RELABELLING OF OUTPUT TERMINALS Kit 179

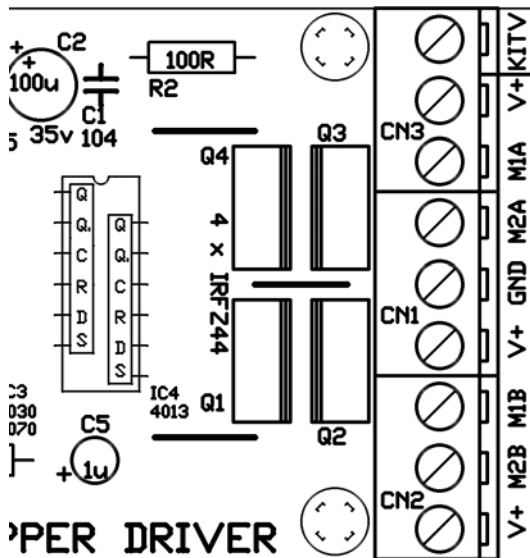
Please note we made some errors on the labelling of the output terminals on this PCB.

Two errors in the schematic (all on the 4030) have now been corrected in the documentation.

The correct labelling is shown to the left.
